INTERFACE REVISION NOTICE

INTERFACE CONTROL DOCUMENT

ICD NO. LID-340-10000

ICD TITLE
PGNS (LGC-CDU-PSA and Signal Condition Installation

SECT. N-N

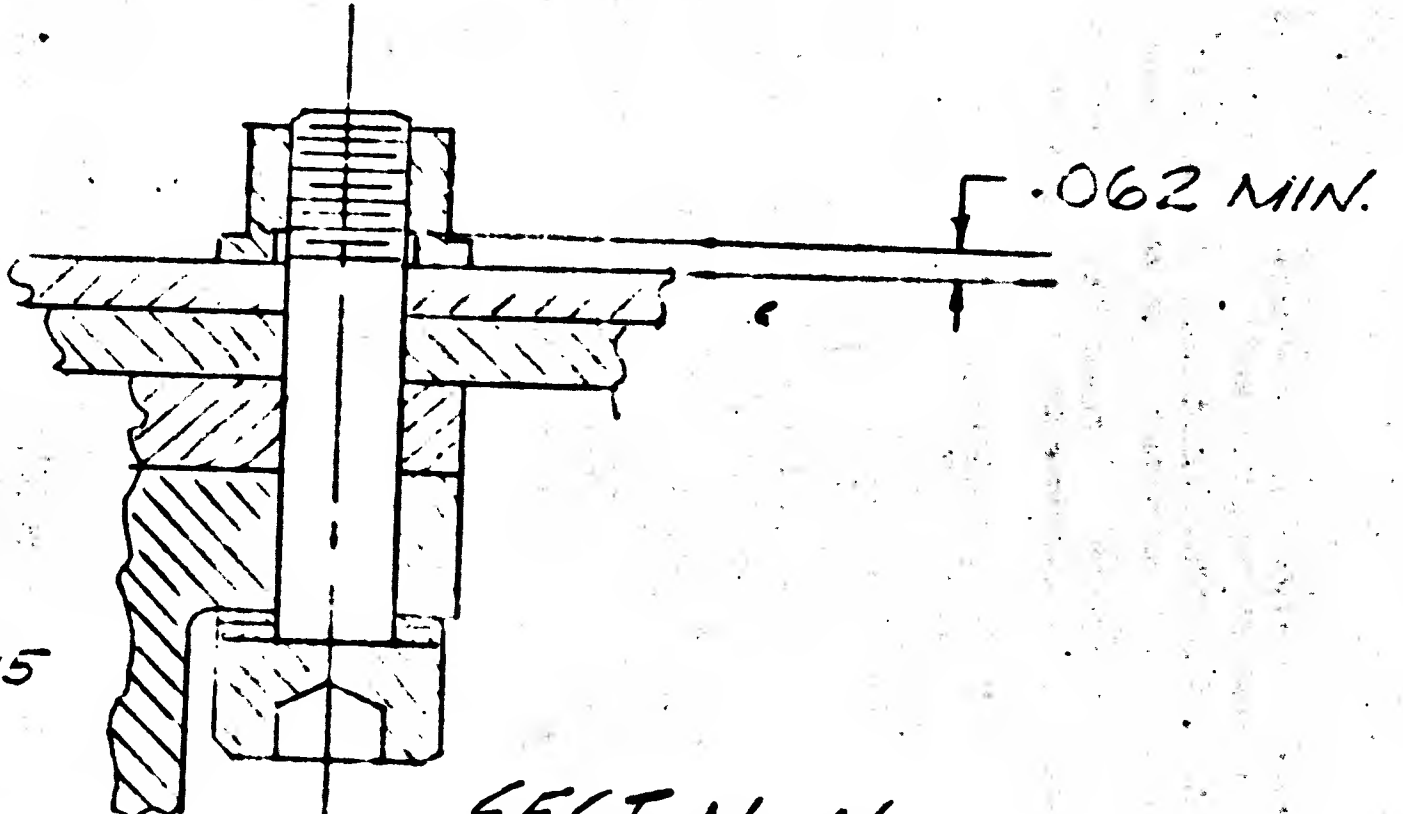
DESCRIPTION: IN SECTION N-N ADD. COUNTERBORE DIM. AS SHOWN.

REASON: DRAWING ERROR

Figure 4 Total Attitude Signals

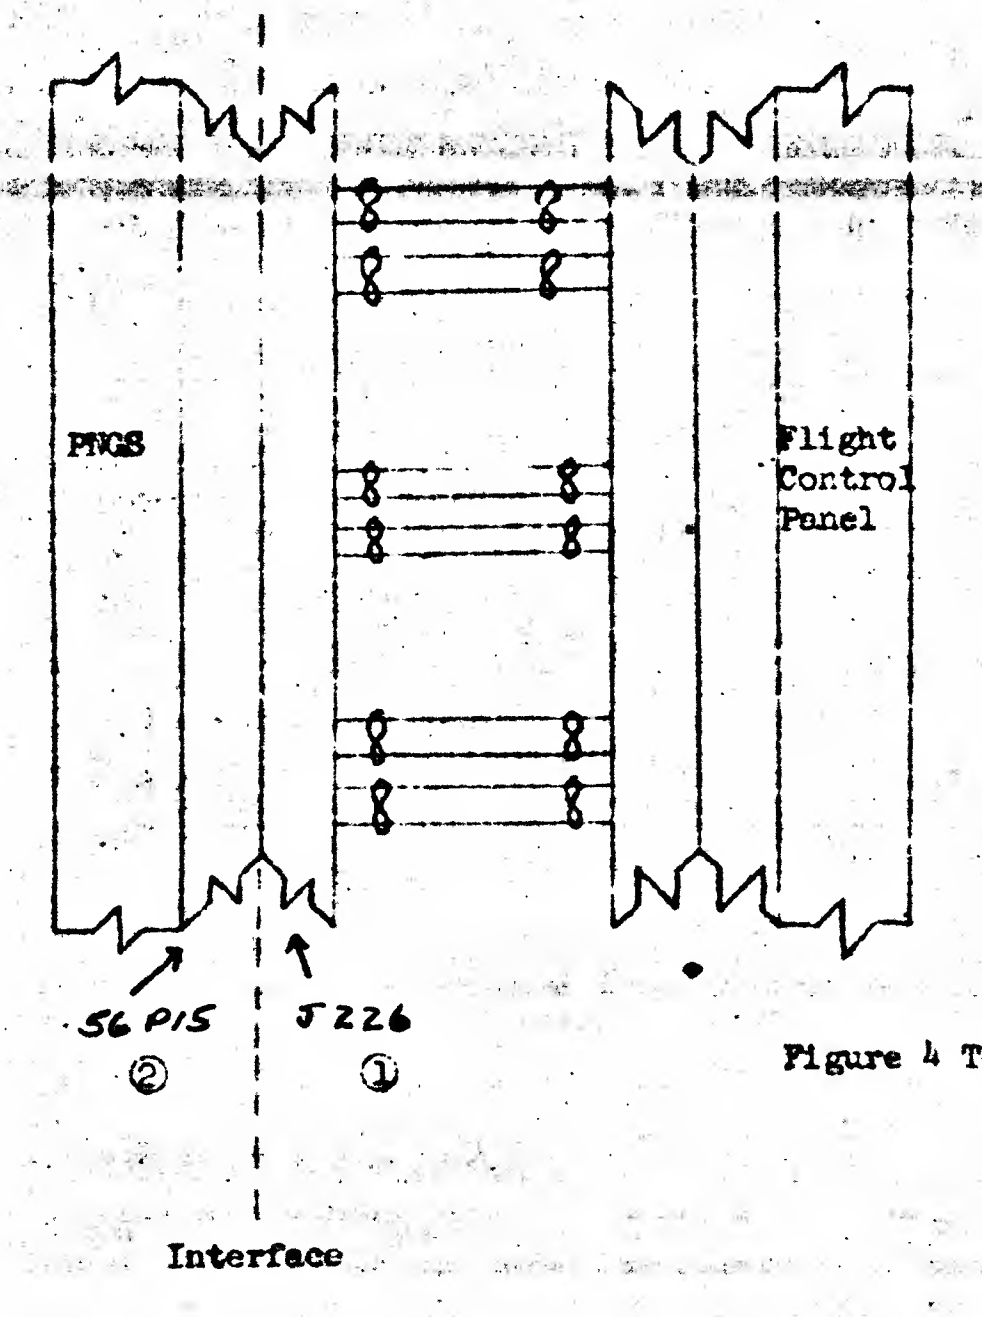
Sheet 8: Delete Figure 4 and replace with Figure 4 (attached).

ATTITUDE ERROR INTERFACE WIRING

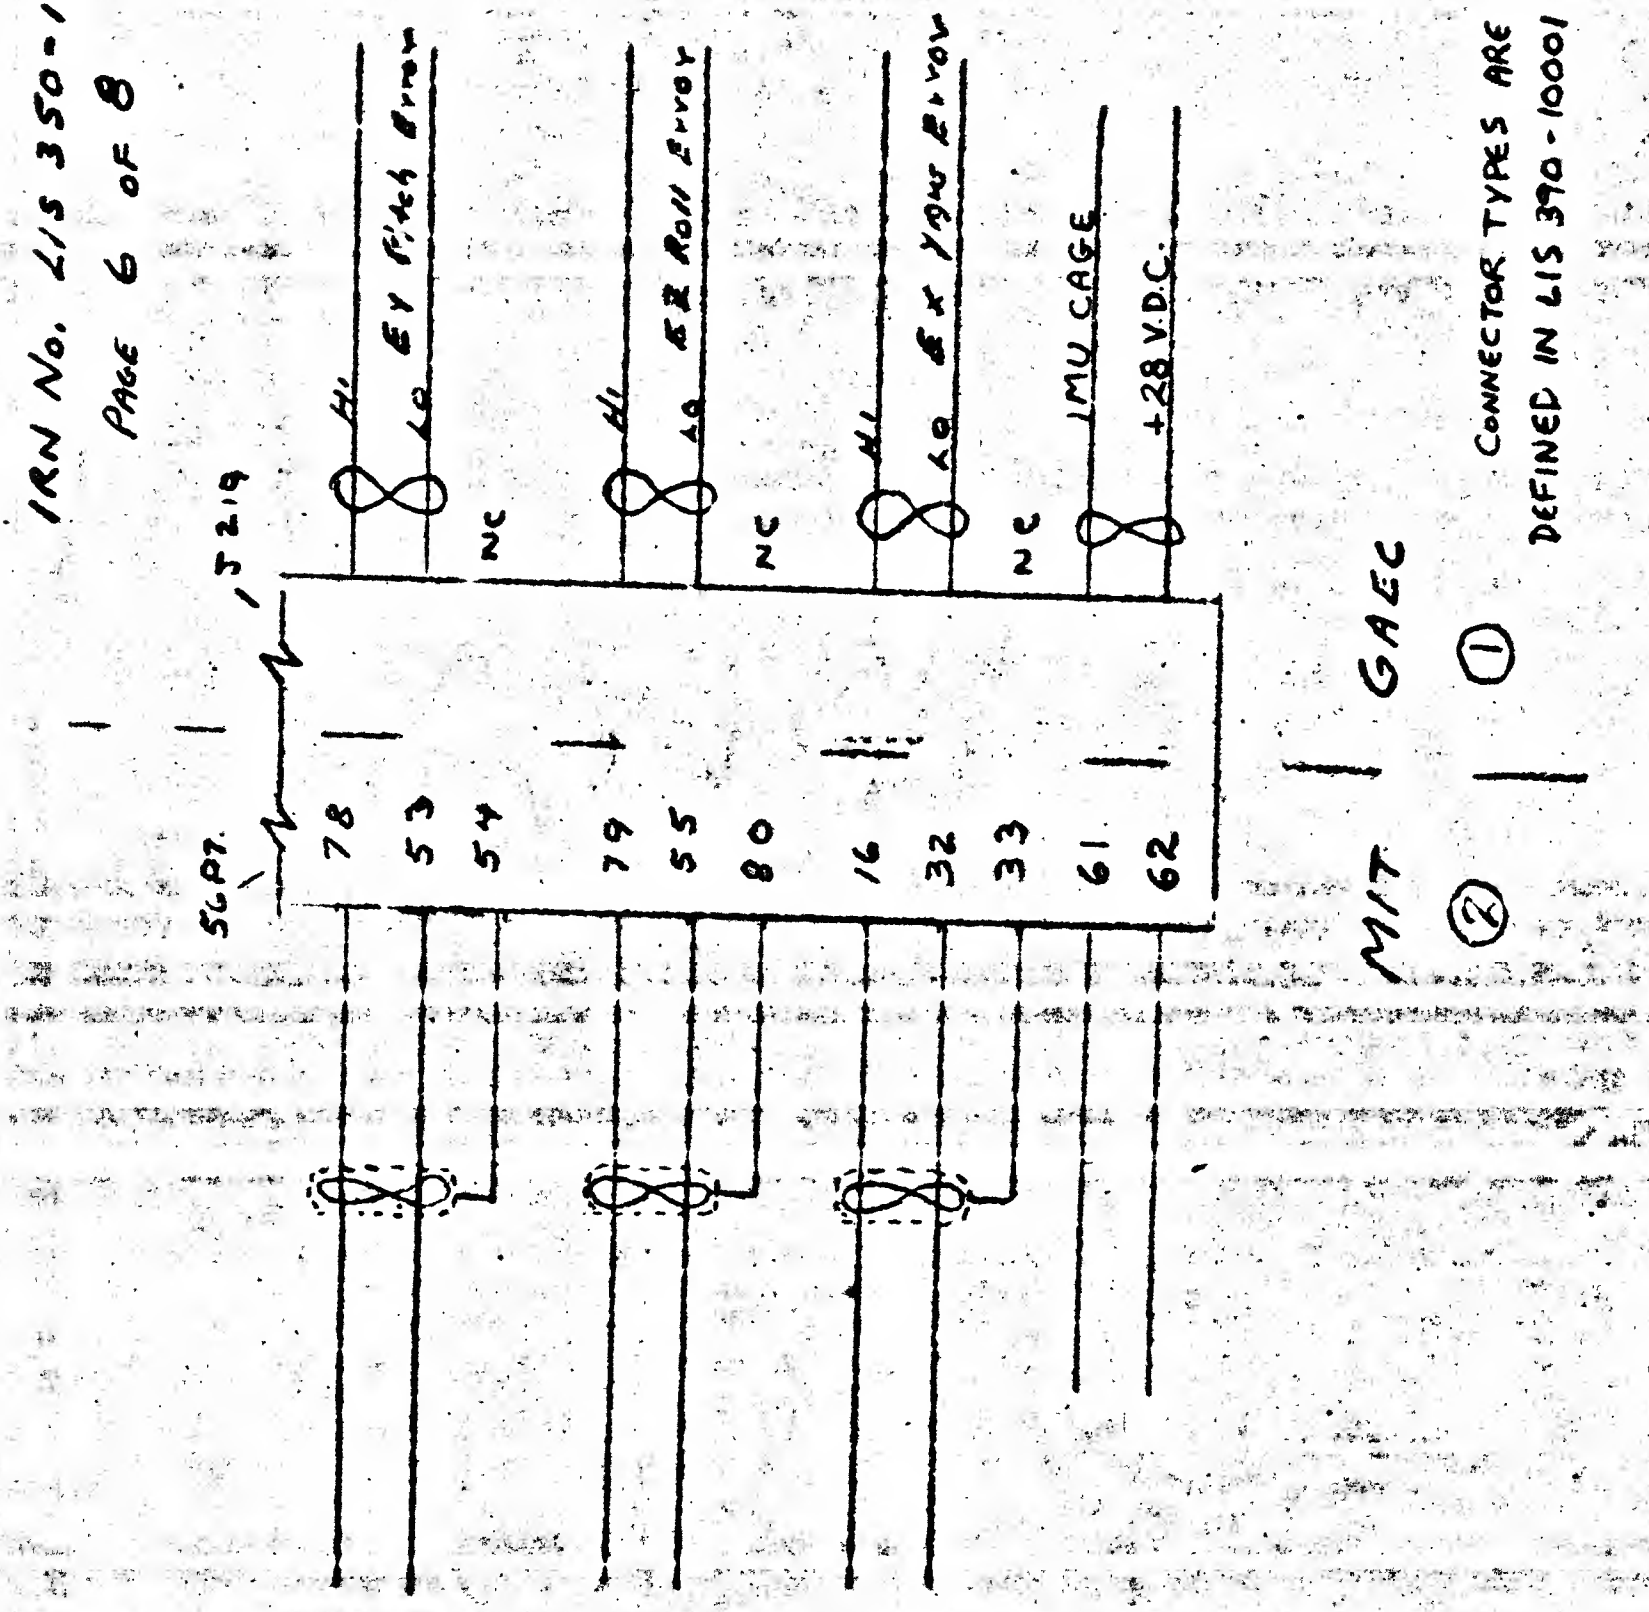
Add:
Figure 6: Attitude Error Interface Wiring
Figure 7: Attitude Error Interface Schematic

IMU CAGE INTERFACE

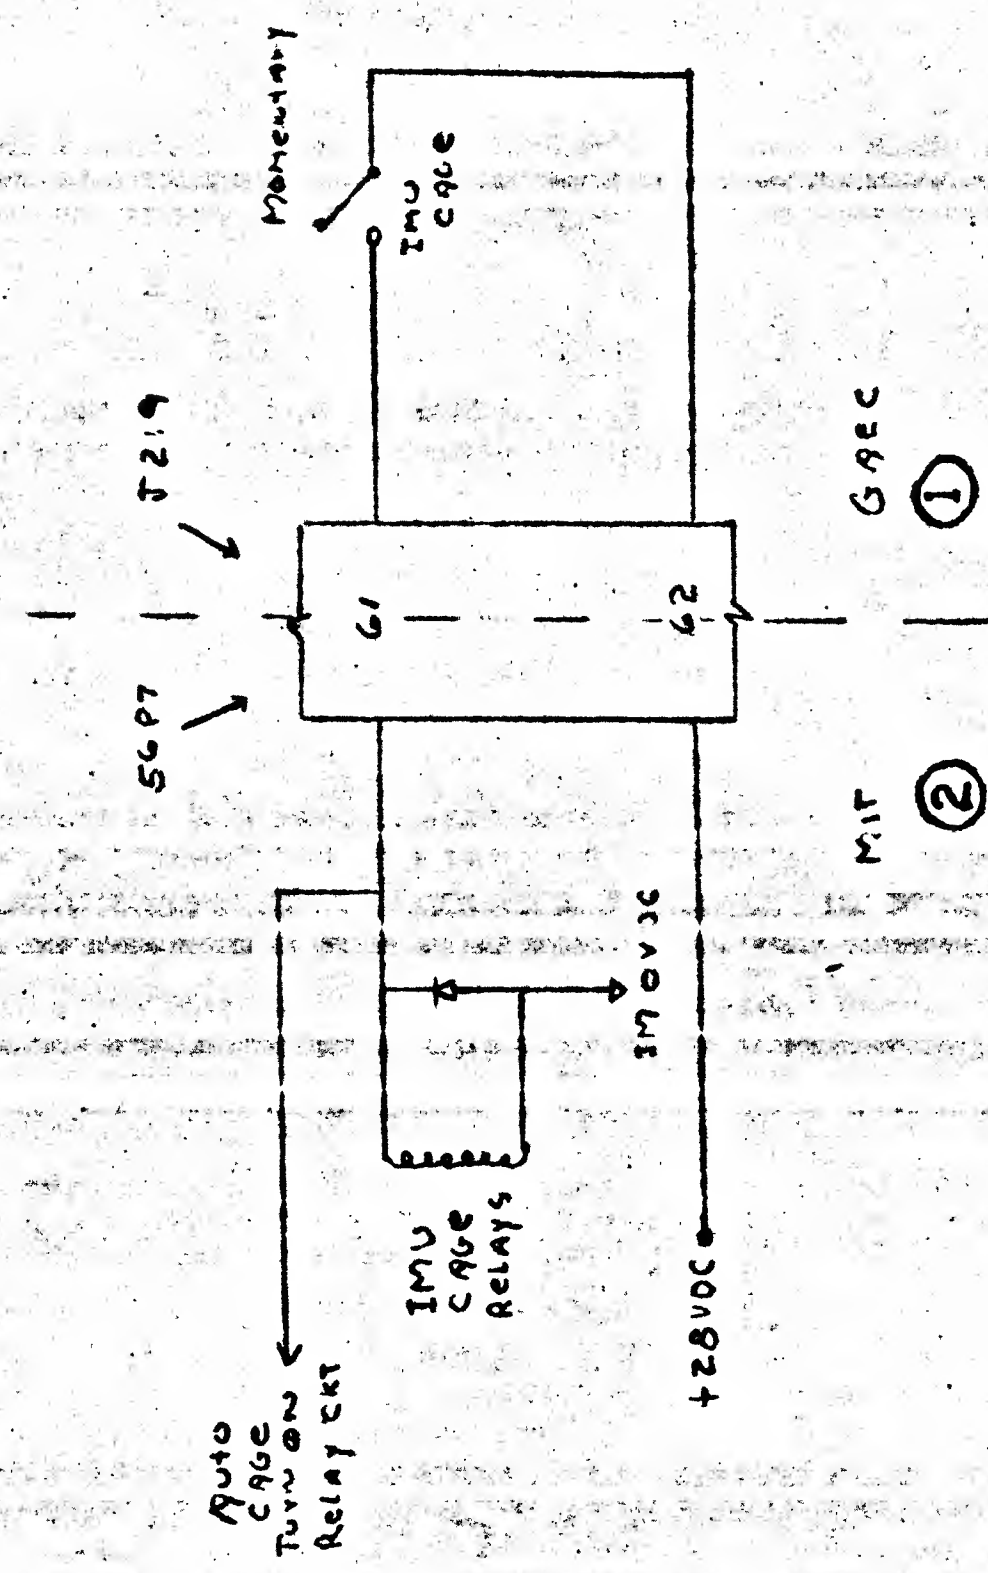
3.1 The IMU Cage Signal from LEM to the PGNS shall be as shown on Figure 8

Add:
Figure 8: IMU Cage Interface Schematic

3.2 Voltage: 28 VDC

3.3 Current: The maximum current shall be 0.075 ampere At 28 V DC

3.4 The switch closure is the signal to cage the IMU

FIGURE 2

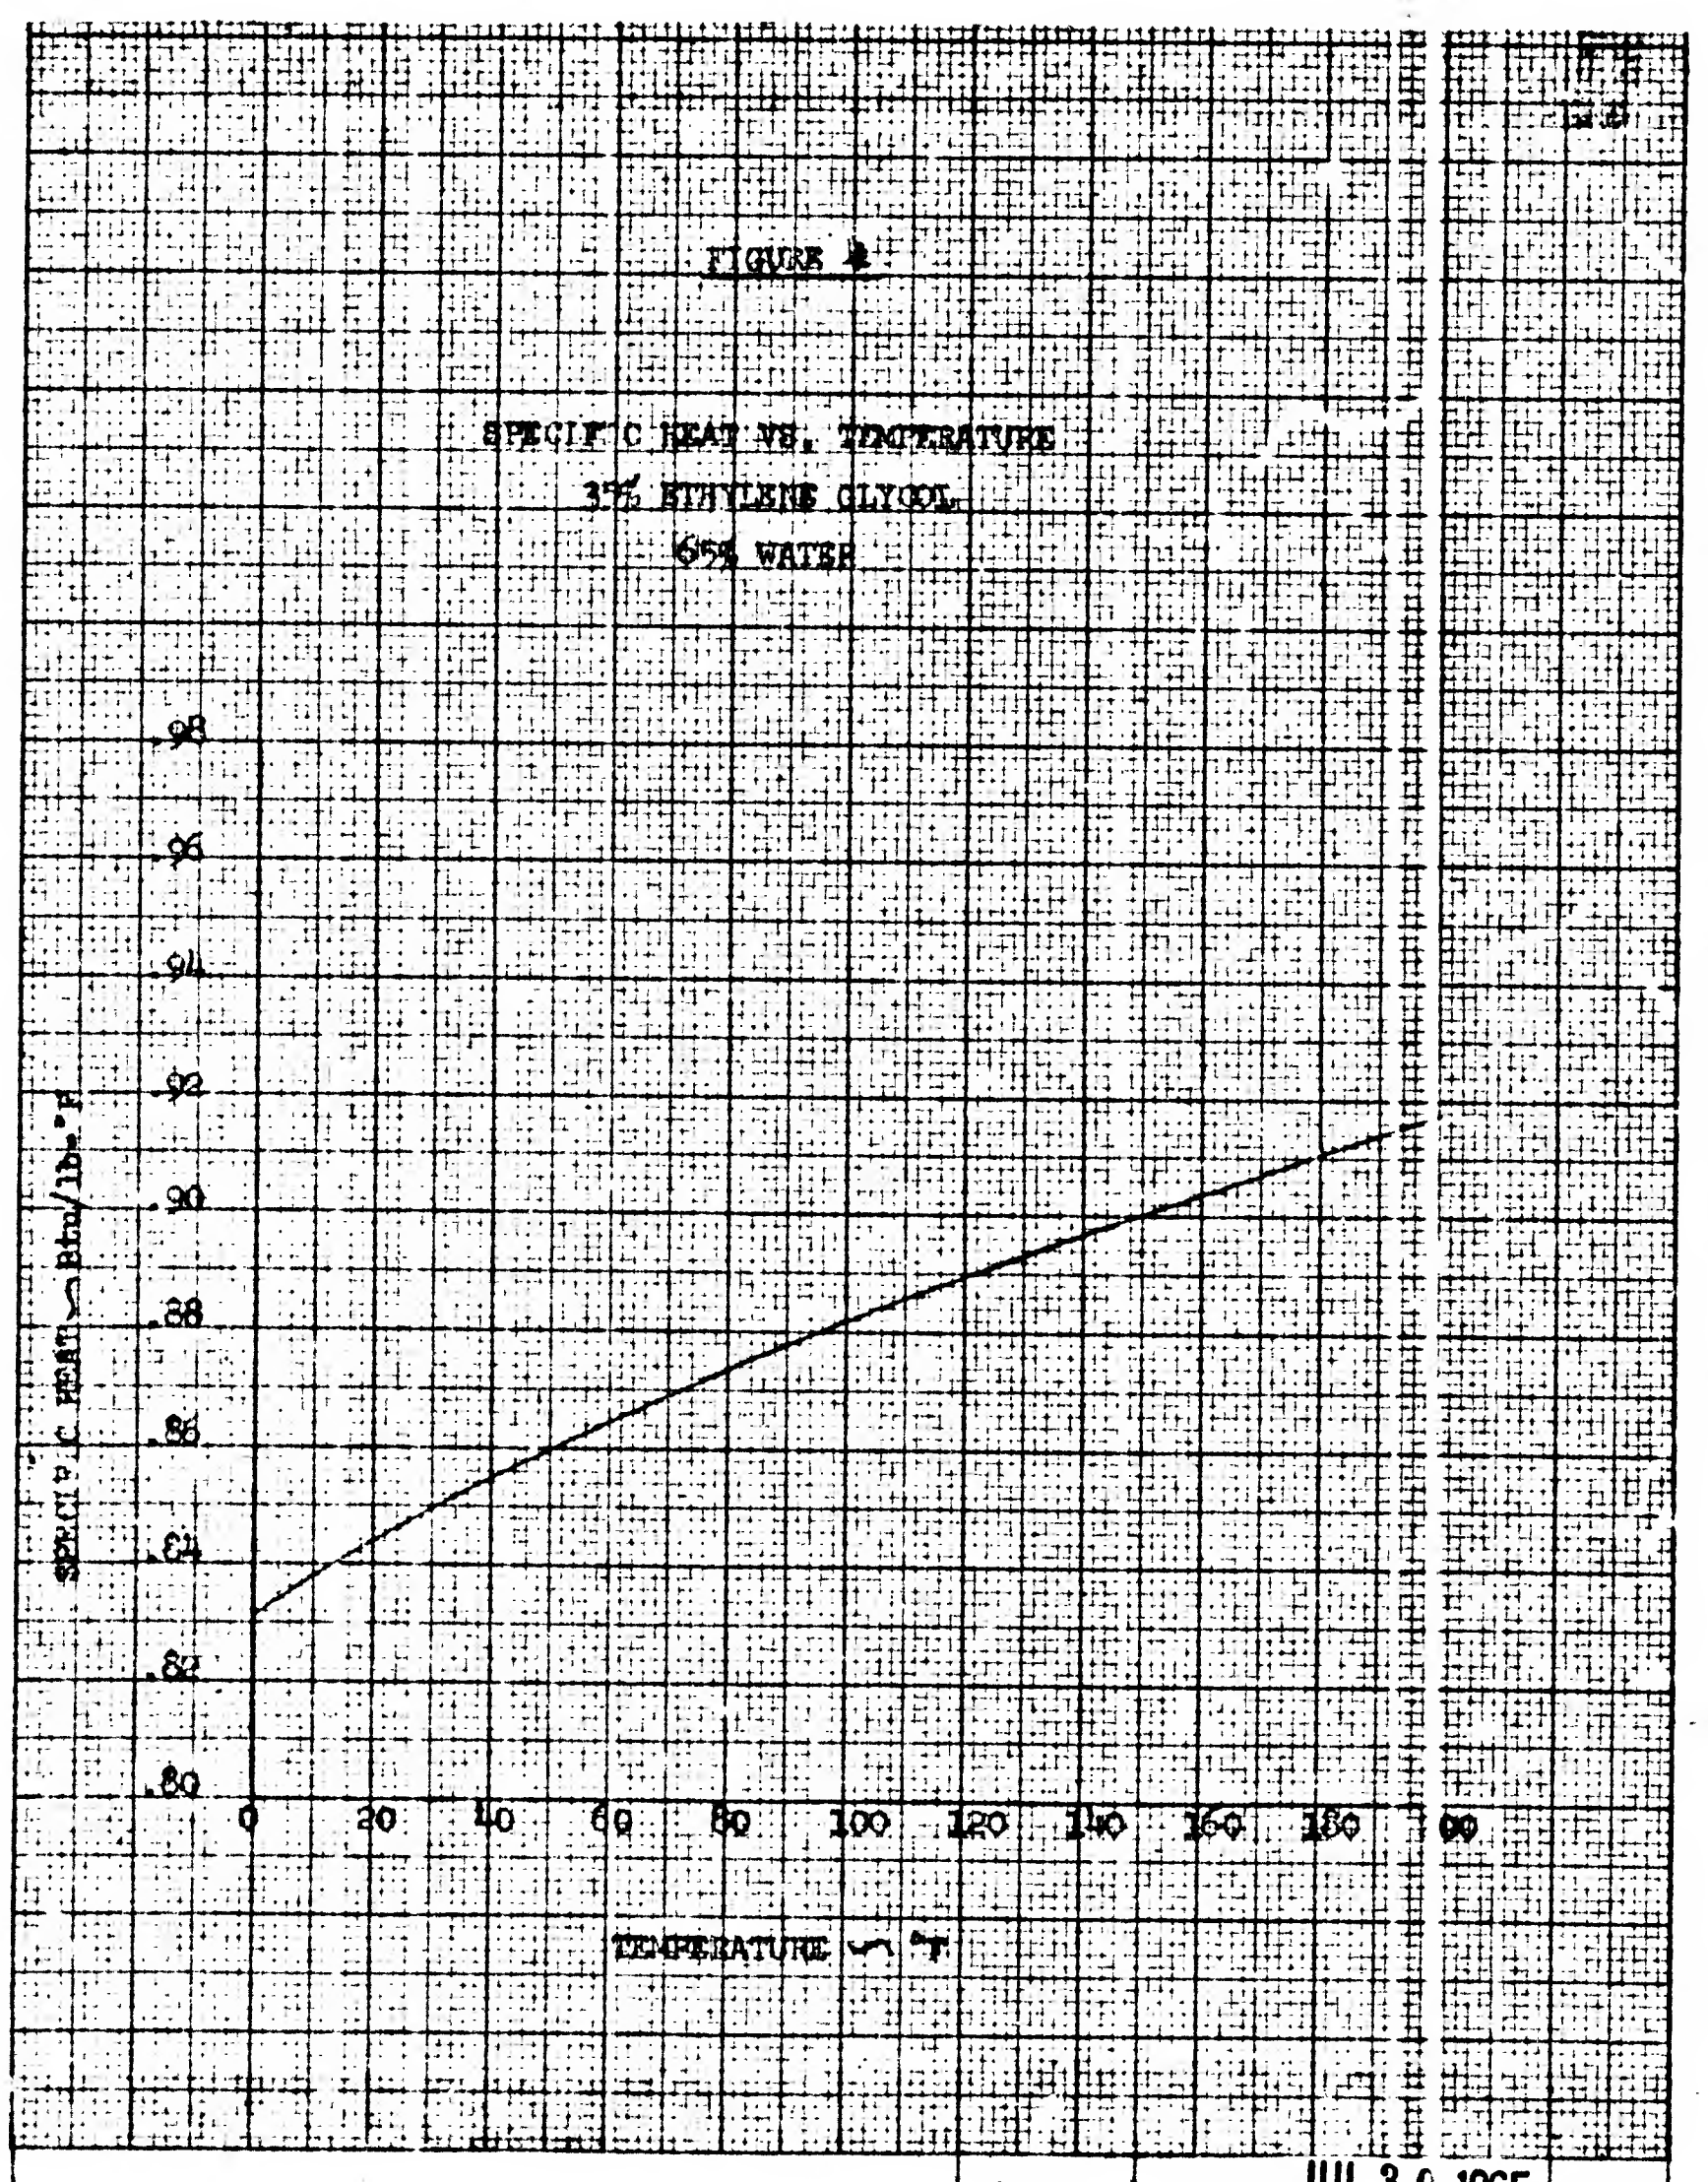
Add to Figure 2

For LM-1 coolant flow rates refer to Paragraph 1.7

The coolant flow rate for LM-1 flight operation of the PGNS (LGC, CDU, PSA, IMU & PTA) shall be within the range of 28 and 66 lbs per hour. The same coolant inlet temperature range of 32°F to 50°F shall still apply.
